UNITED STATES PATENT AND TRADEMARK OFFICE

10/543,077

Office Action Summary	Application No. 10/543,077	Applicant(s) DAMBRICOURT, GERY BERNARD MARIE CORNIL	
	Examiner ERIK KASHNIKOW	Art Unit 1794

DETAILED ACTION

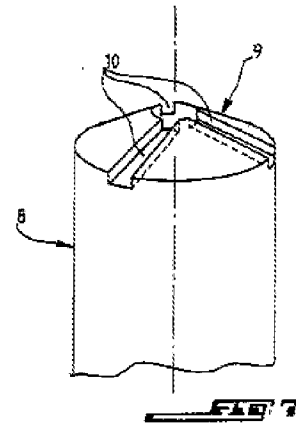
22. In regards to claim 58 Dambricourt teaches that the tube be formed by injecting the polymers into a mold cavity which has a mold insert which contains a central part which has a free upper end and is centered on the tube (paragraph 0011). In regards to the requirement that the impression bears a resemblance to the tube skirt, while

Dambricourt is silent regarding this the pictures shown by Dambricourt show the same features as the pictures shown by Applicant (Fig 5 Dambricourt (top) Fig 5 applicant (bottom)).

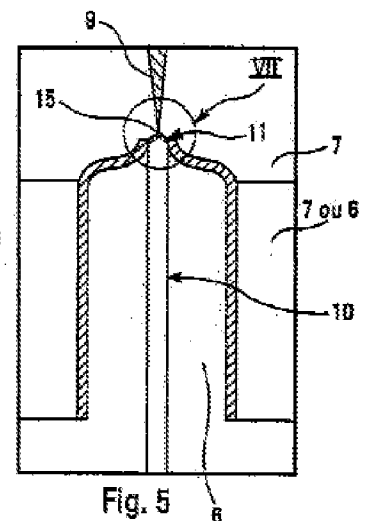
Dambricourt also shows in the feed or supply channels forming an apex wall (Figure 7).

Fig. 9

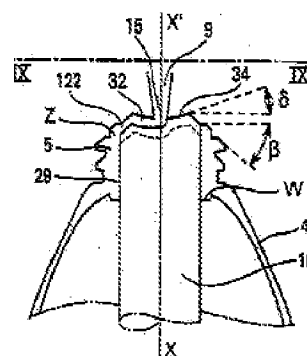
46. In regards to claim 64 Nishikawa shows a view of a conventional laminate figure, which includes a ring of material similar to applicants under the neck (See figure 2 of the prior art compared to figure 9 of Applicant).
